## NOTICE OF DECISION

DATE OF NOTICE: November 14, 2016  
FILE: SP-17-16  
TYPE OF APPLICATION: Site Plan Review to modify Condition of Approval #5.2 of the Hickory Station Phase III Site Plan Review approval (SP-10-15); the proposed modification eliminates the requirement to plant trees in the front yard setback along Hickory Street.  
REVIEW BODY: Staff (Type I-L)  
PROPERTY OWNER/APPLICANT: Hickory Station LLC; Patty & Gary Davenport;  
PO Box 2744; Albany, OR 97321  
APPLICANT'S REPRESENTATIVE/ENGINEER: Troy L. Plum, PE; TKP Engineering; PO Box 374; Corvallis, OR 97339  
ADDRESS/LOCATION: 560 Hickory Street NW  
MAP/TAX LOT: Benton Co. Assessor's Map No. 11S-04W-01DA; Tax Lot 1600  
ZONING: CC (Community Commercial) District; /FP (Floodplain Overlay)

HICKORY STATION PHASE 3

RETAINING WALL  
 EXHIBIT

PRELIMINARY LANDSCAPE PLAN  
HICKCORY STATION - PHASE 3

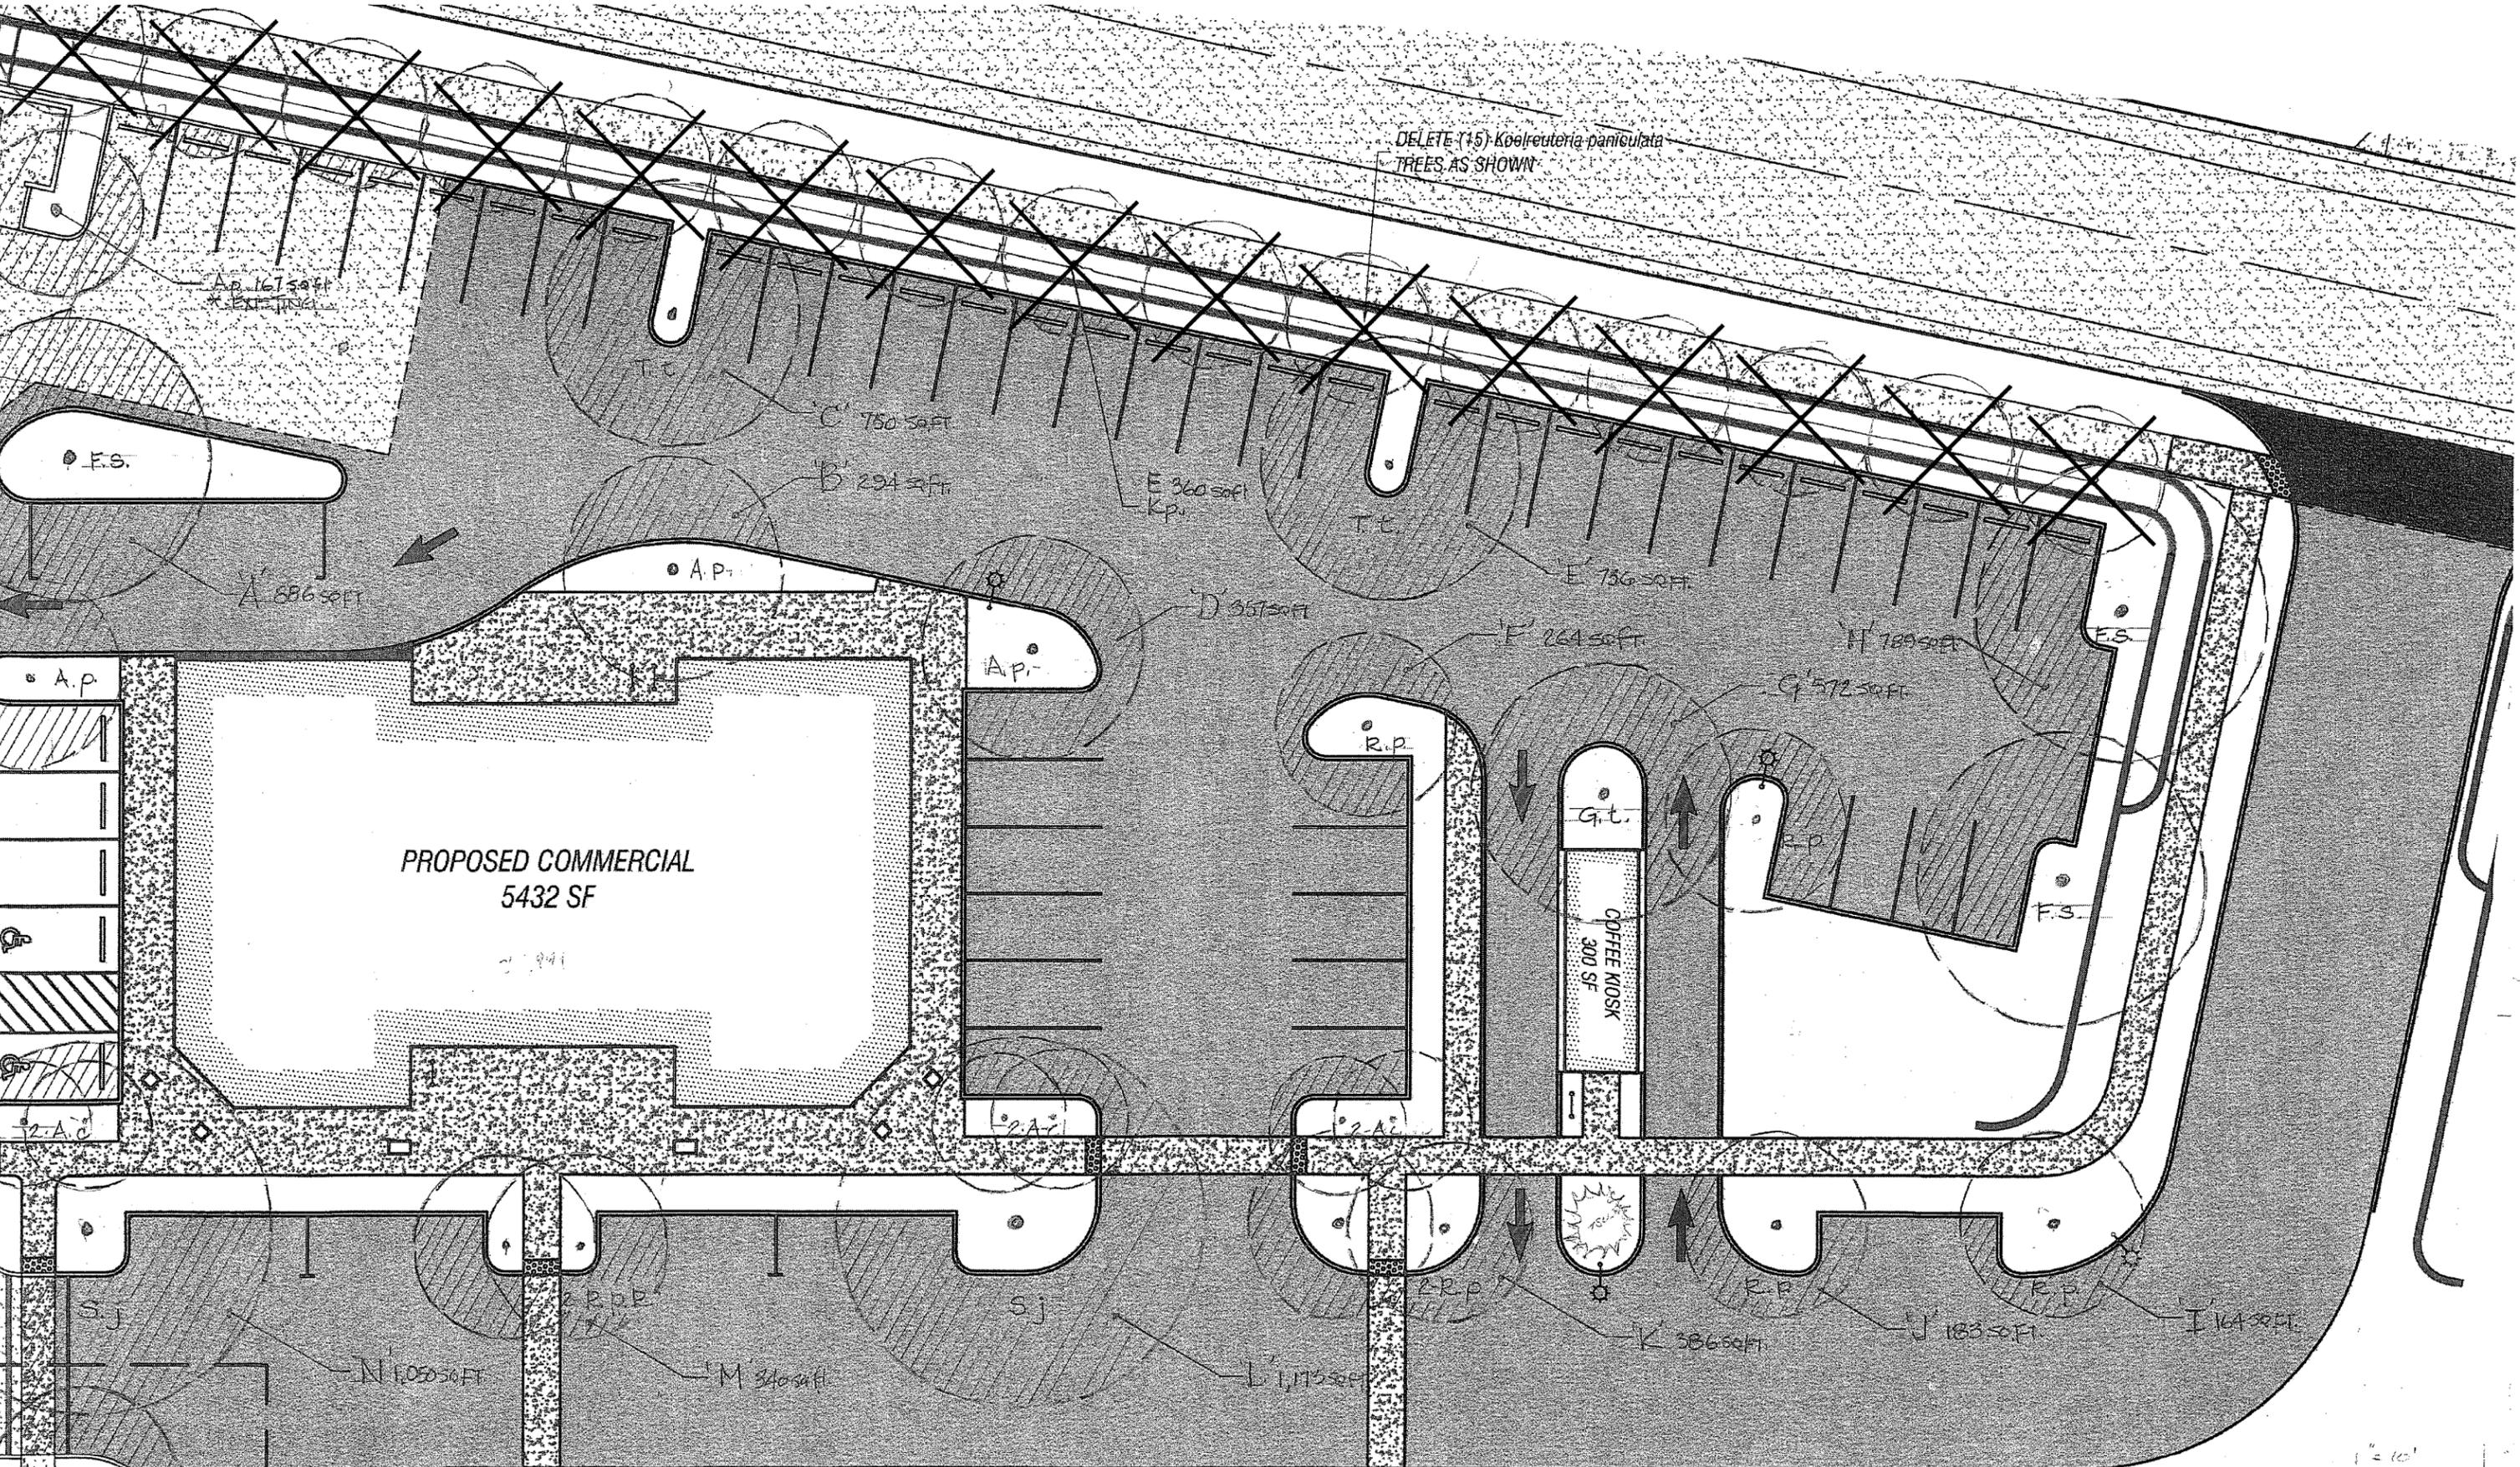
DELETE (15) Koolreuteria paniculata TREES AS SHOWN
